PUBLIC CONSULTATION BY KEADBY GENERATION LIMITED
PROPOSED CHANGES TO THE KEADBY 3 CARBON CAPTURE POWER STATION PROJECT
CONSULTATION RUNS UNTIL SUNDAY 20TH MARCH 2022 AND WE WELCOME YOUR
FEEDBACK ON THE PROPOSED CHANGES

KEADBY 3
CARBON CAPTURE
POWER STATION
A collaboration between SSE Thermal and Equinor

Proposed Changes to the Project

Figure 1: Proposed Extensions to Order Limits

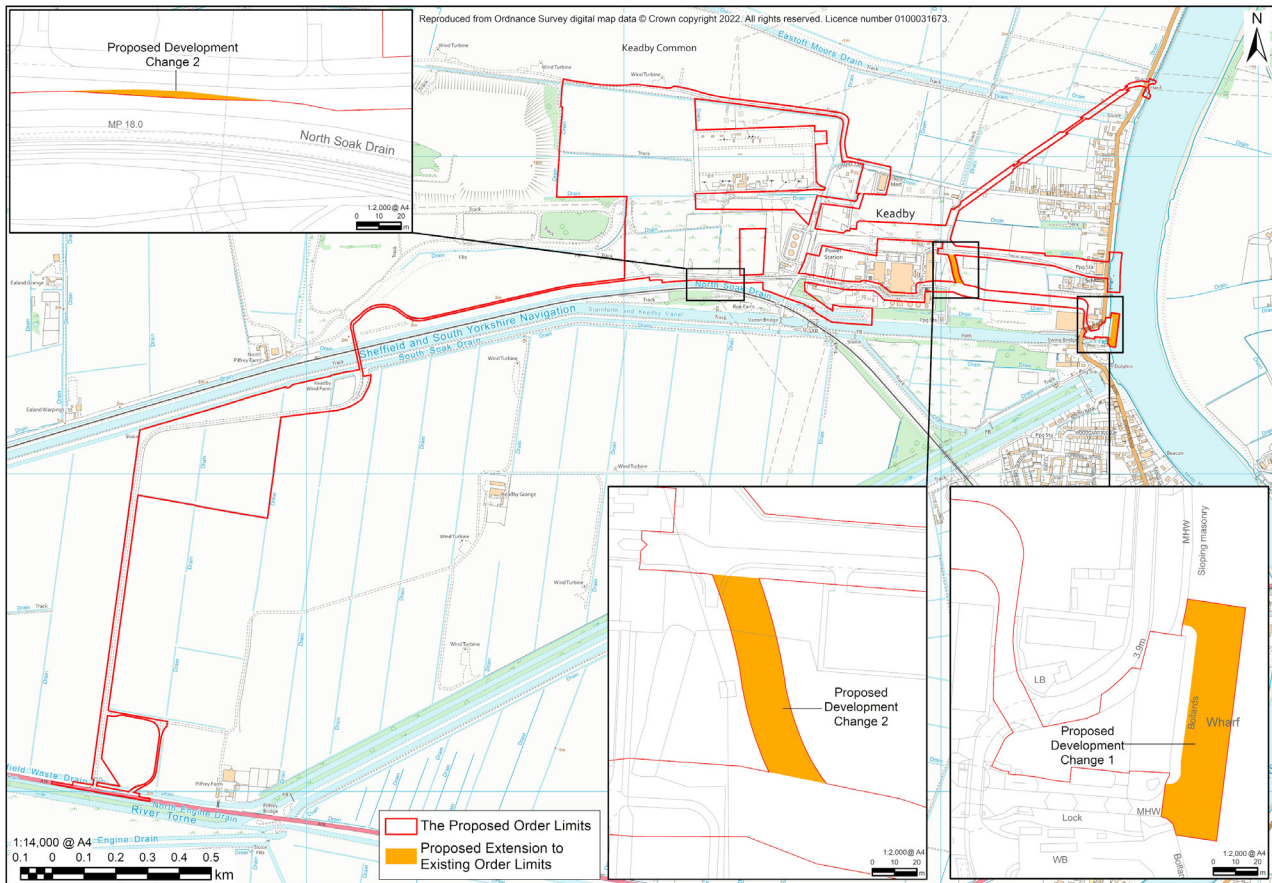
The five Proposed Changes can be summarised as follows. Proposed Changes that affect the Order Limits are shown on Figure 1:

1. Inclusion of riverbed within the Waterborne Transport Offloading Area (Railway Wharf).

This Proposed Change involves the extension of the Order Limits (the red line boundary) for the Project into the River Trent in order to allow for larger vessels bringing loads to the Site during construction to berth at Railway Wharf. This change does not include any new physical development.

2. Changes to the Additional Abnormal Indivisible Load Route, largely within SSE land.

The Applicant proposes an extension of the existing Additional AIL Route for larger AILs, which was first constructed for the construction of Keadby 2. This is to avoid reliance on routing all AILs through the operational Keadby Power Station due to the potential for health, safety and environmental risks which could otherwise affect the construction timescales and speed of being able to deploy this Nationally Significant Infrastructure Project. The AIL Route would incorporate the temporary use of a section of the Keadby 1 Power Station site, which may require the demolition/relocation of some existing buildings, and be extended slightly north of Keadby Power Station. The route would avoid impacting existing habitats and vegetation, but where this is unavoidable compensation and enhancement measures would be undertaken while all habitats would be re-instated following completion of construction. This change requires a minor extension to the Order Limits, taking in land which already belongs to the Applicant.
